CANAAN VALLEY LODGE

revisions:
A ADDENDUM #2

Canaan Valley Resort Renovations & Additions Davis, West Virginia

1. ADDENDUM #2 - UPDATED WATER HEATER DIAGRAMS - 01/19/12

sheet title:
EROSION & SEDIMENT CONTROL PLAN
sheet number:
C2.0

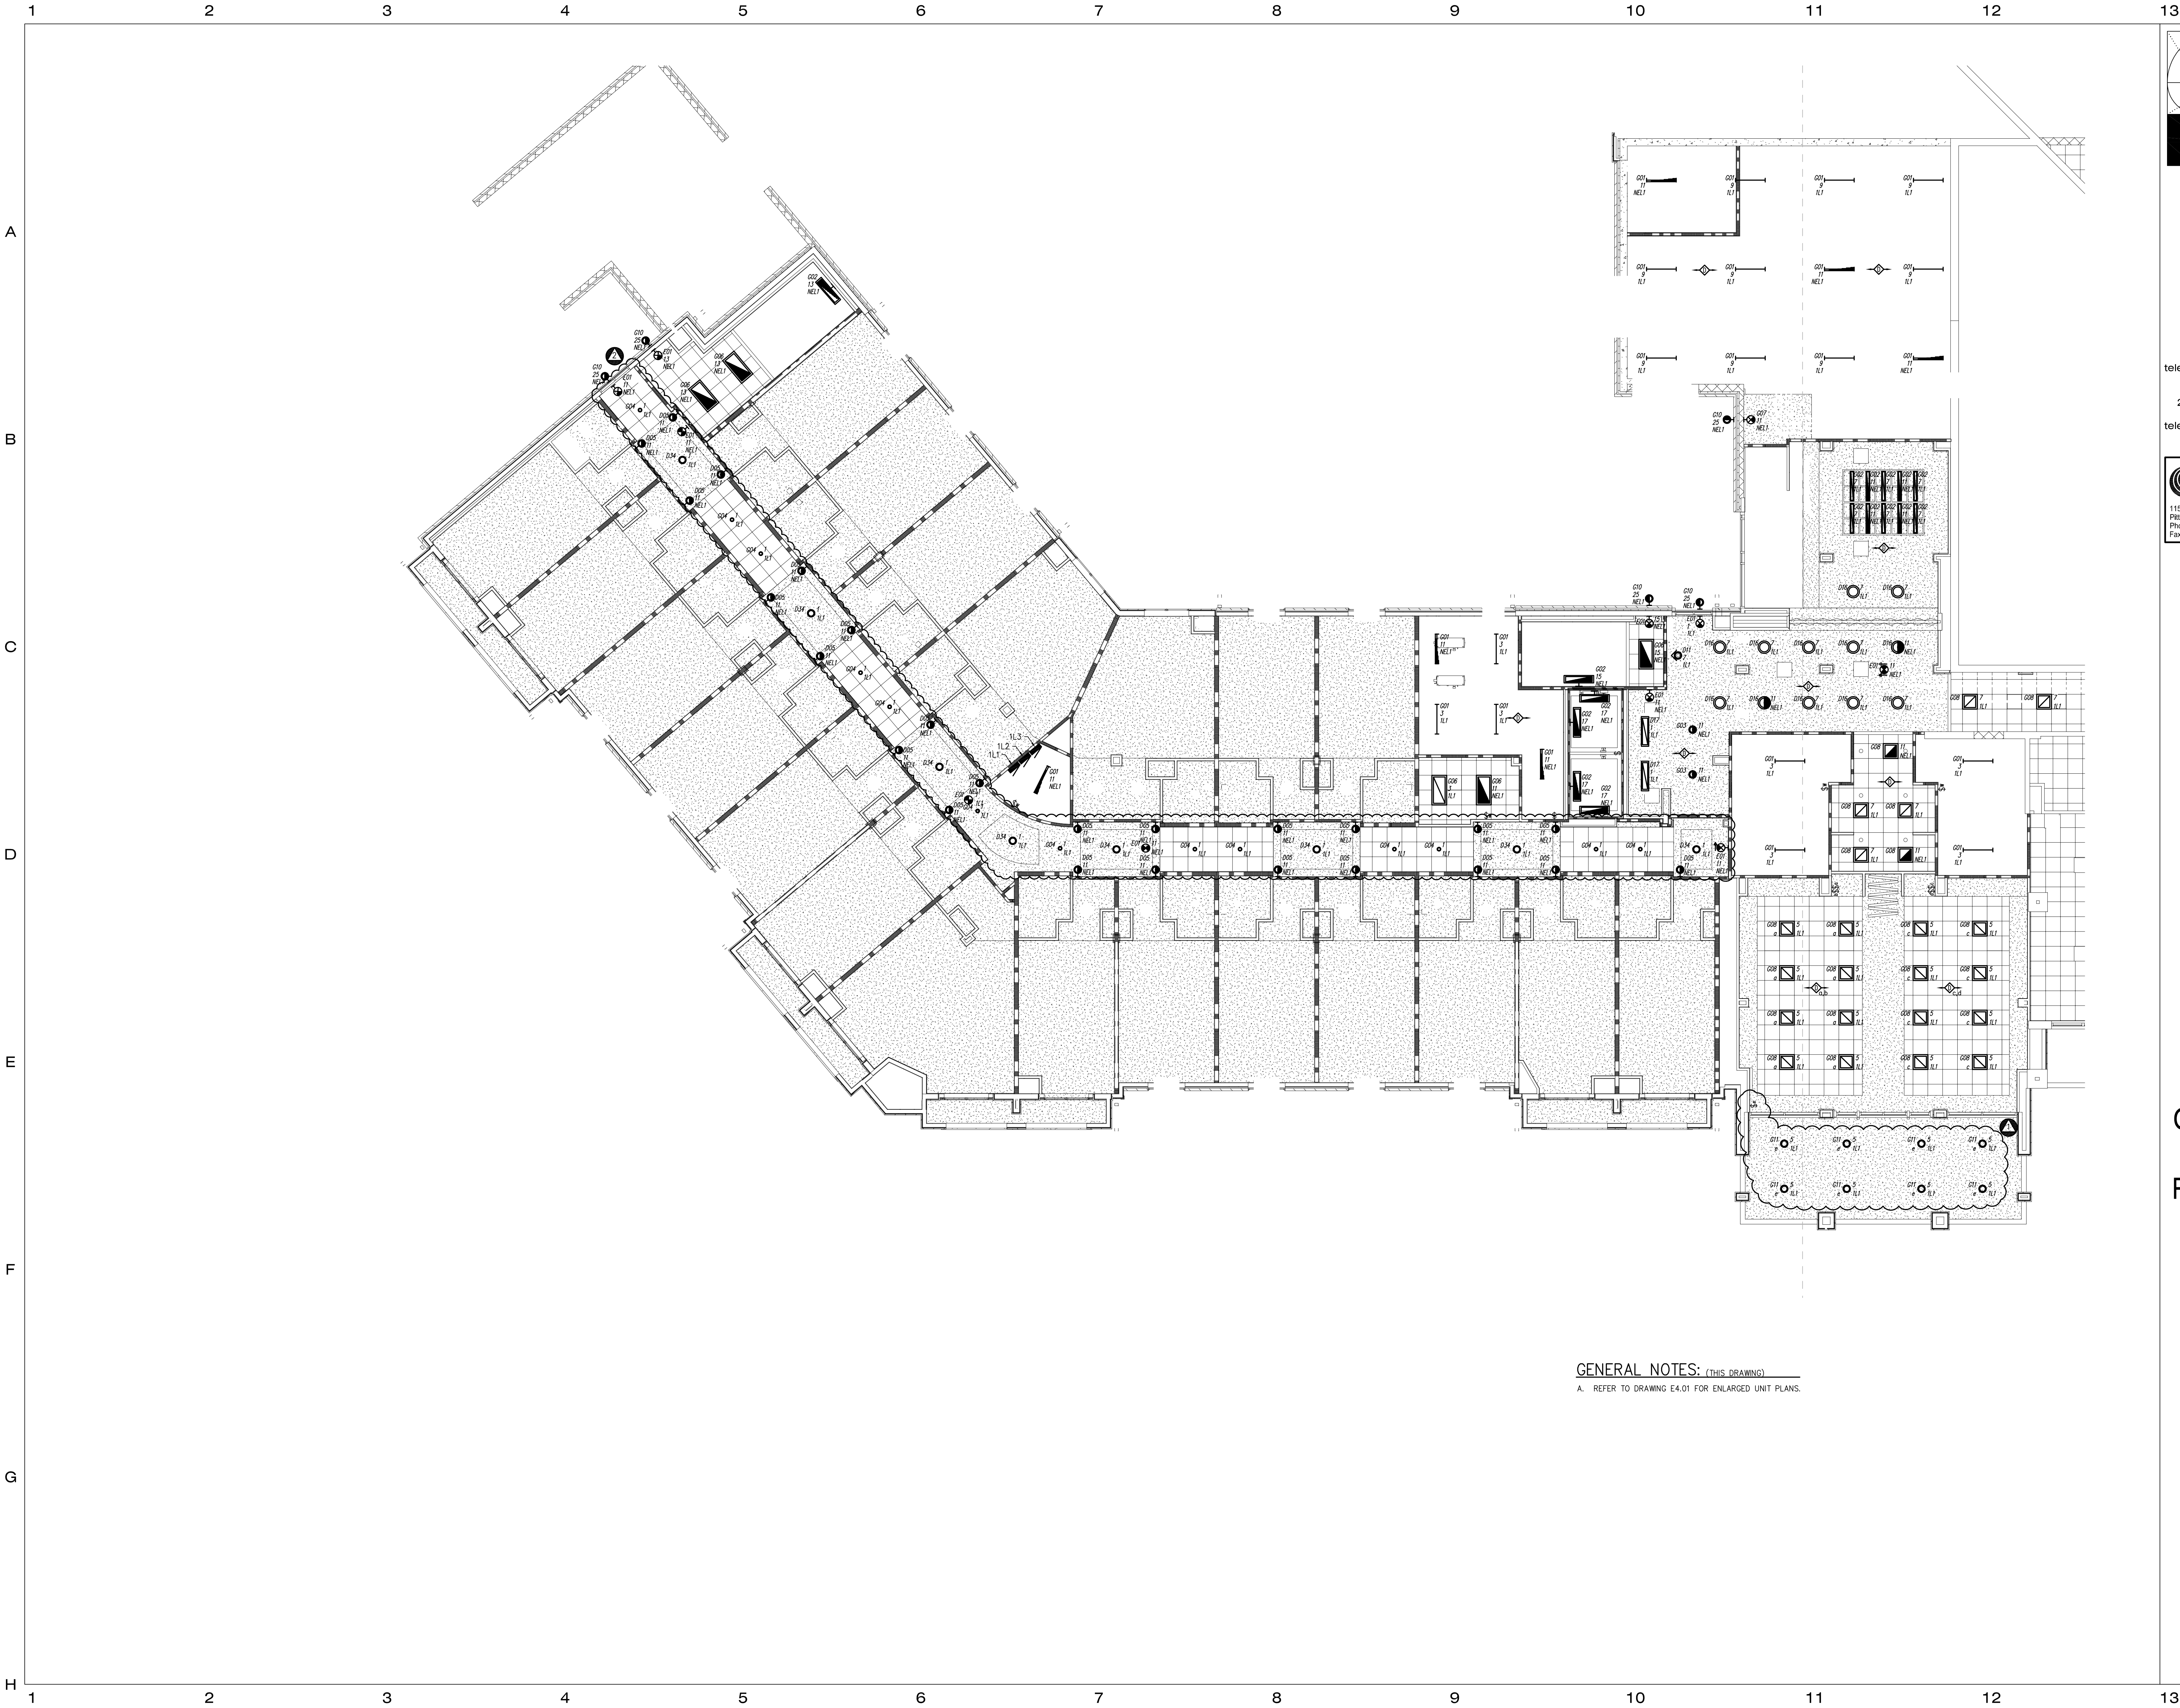
NO.	DESCRIPTION
1	PROPOSED CONTOURS & ADD SILT FENCE
